# **ADDENDUM**

**RFB NO. 319002 - ADDENDUM NO. 1**

**ROBERTSON ROAD PHOTOVOLTAIC SOLAR ARRAY**

FLOOR PLANS -  
 ELECTRICAL

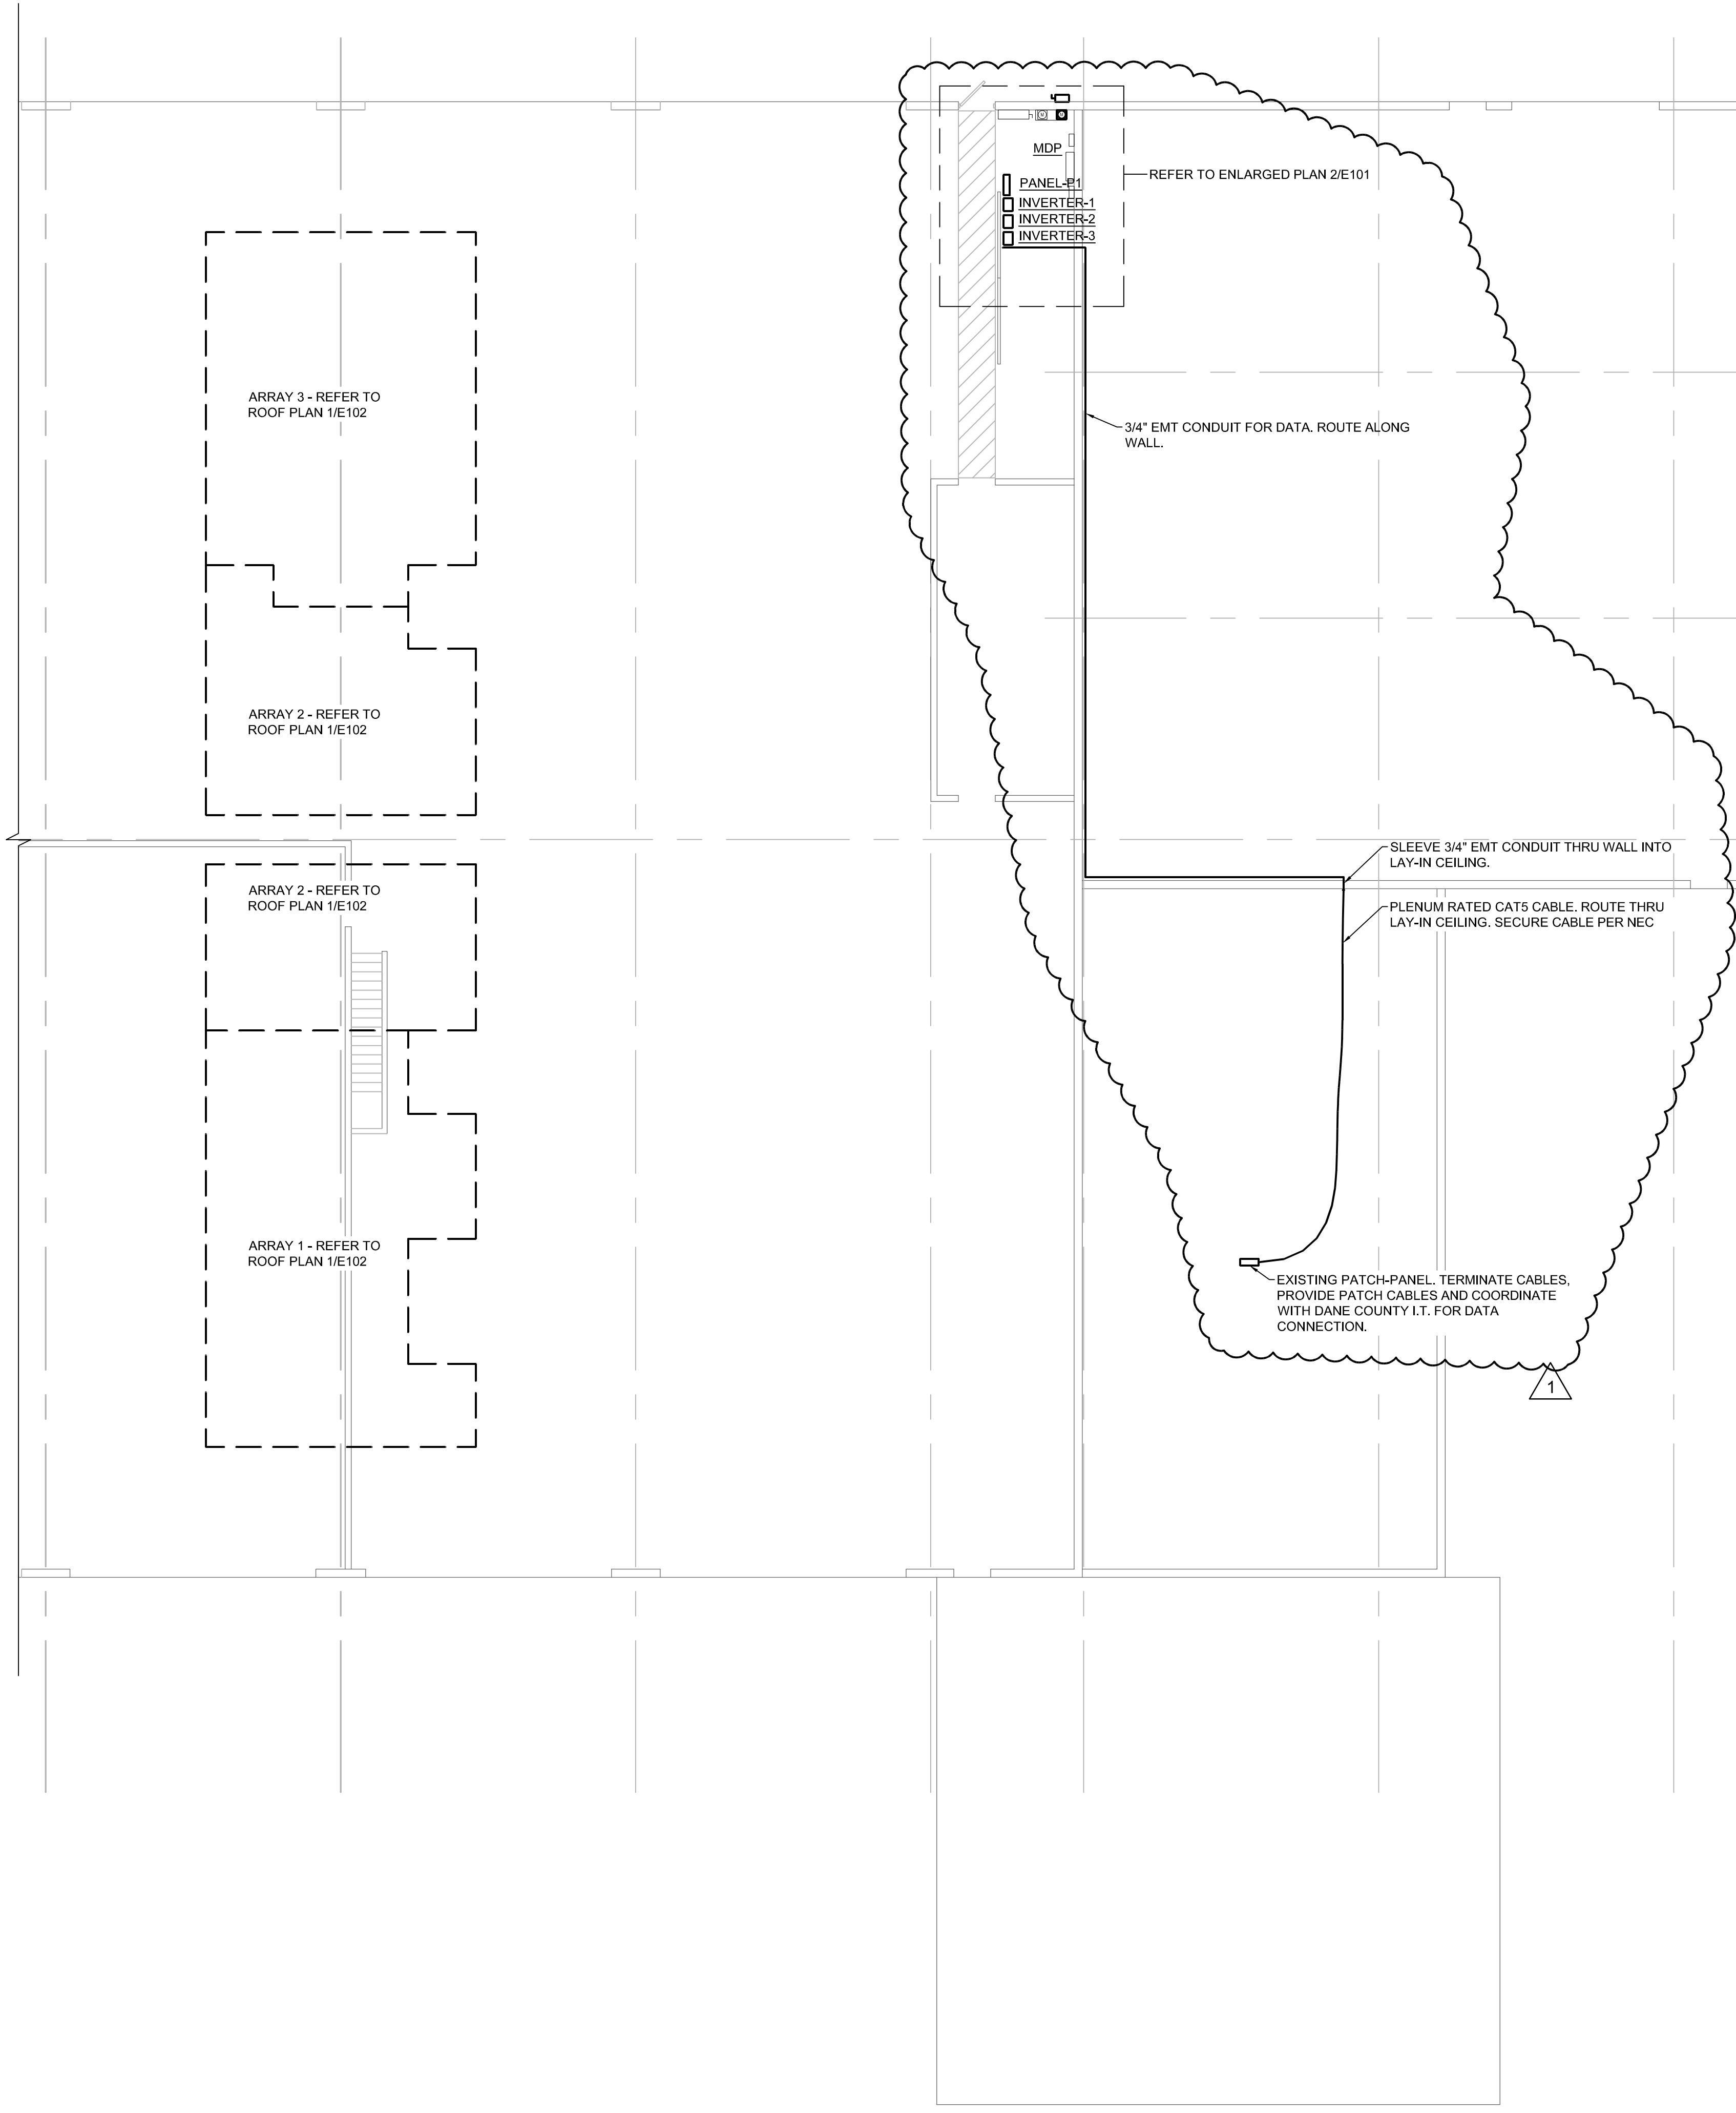
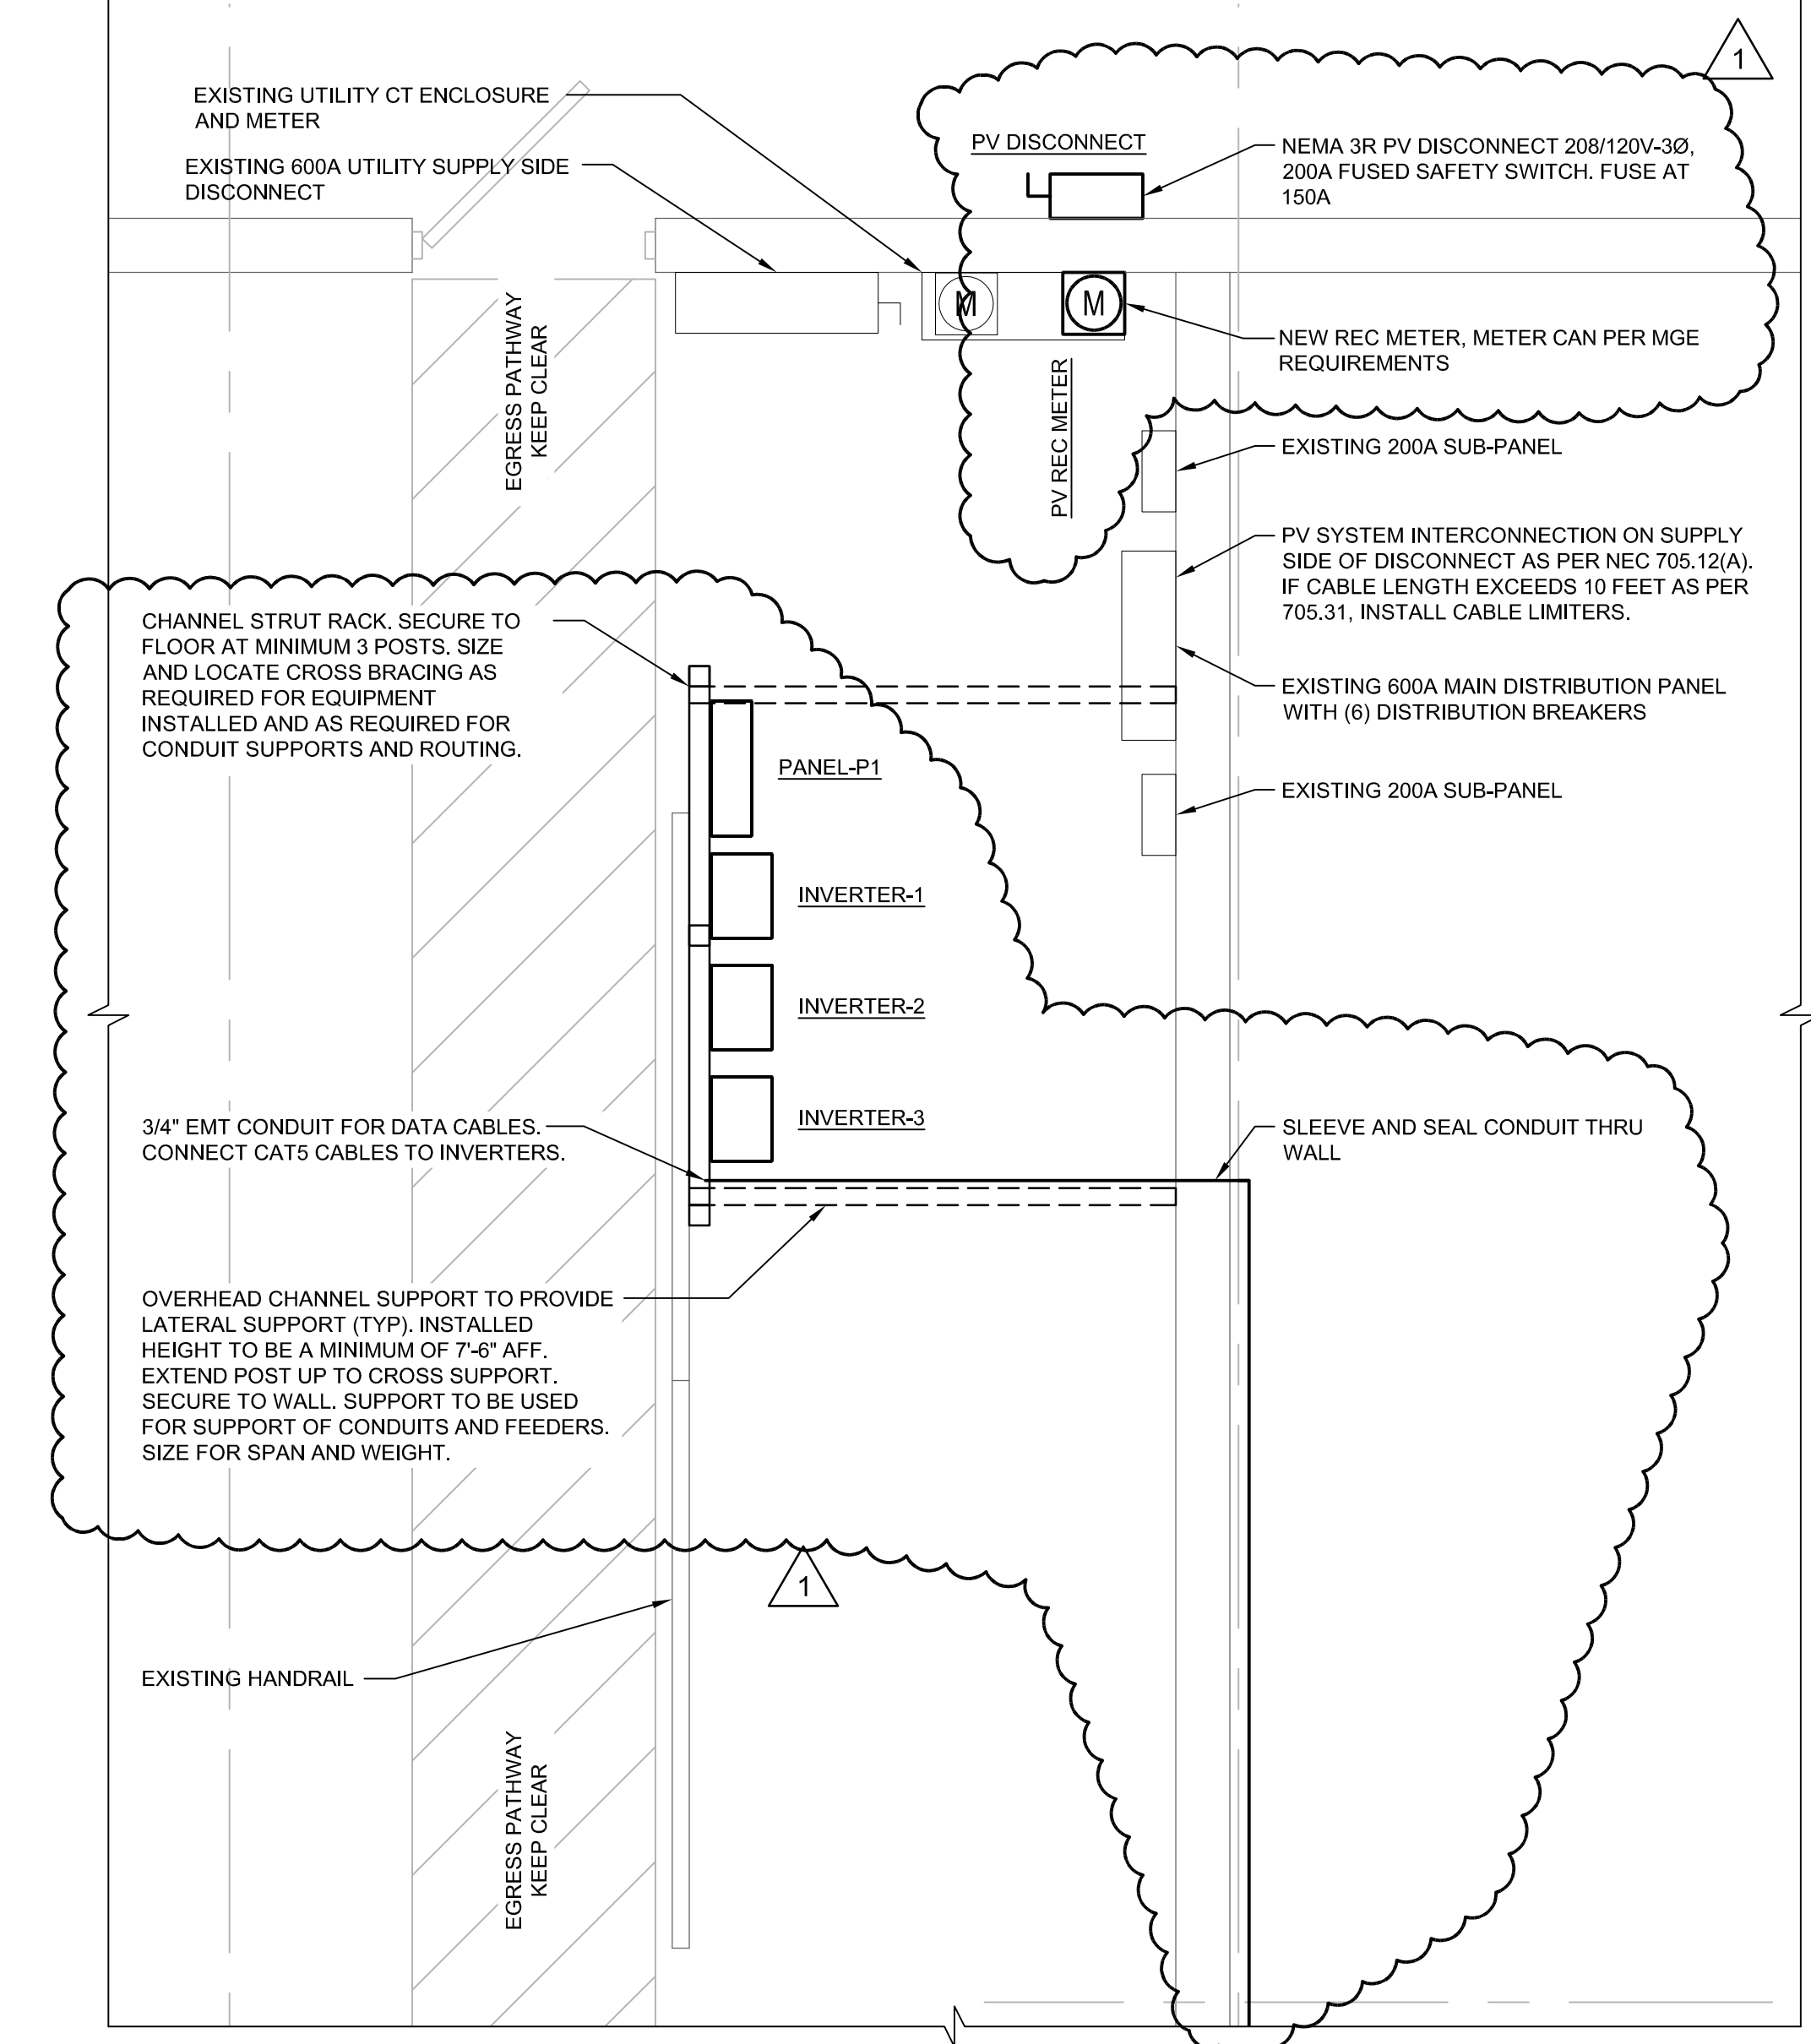
**Q1:** Where are we penetrating to get into the building, straight into the roof or conduit down the side of the building?

**Q2:** Is there a specified/recommended spacing for attachment points on the standing seam roof?

**A1:** The conduit to be routed down through the roof. Penetrations need to be kept to as few as possible.

**A2:** Attachment points on the roof to be determined by the selected contractor.
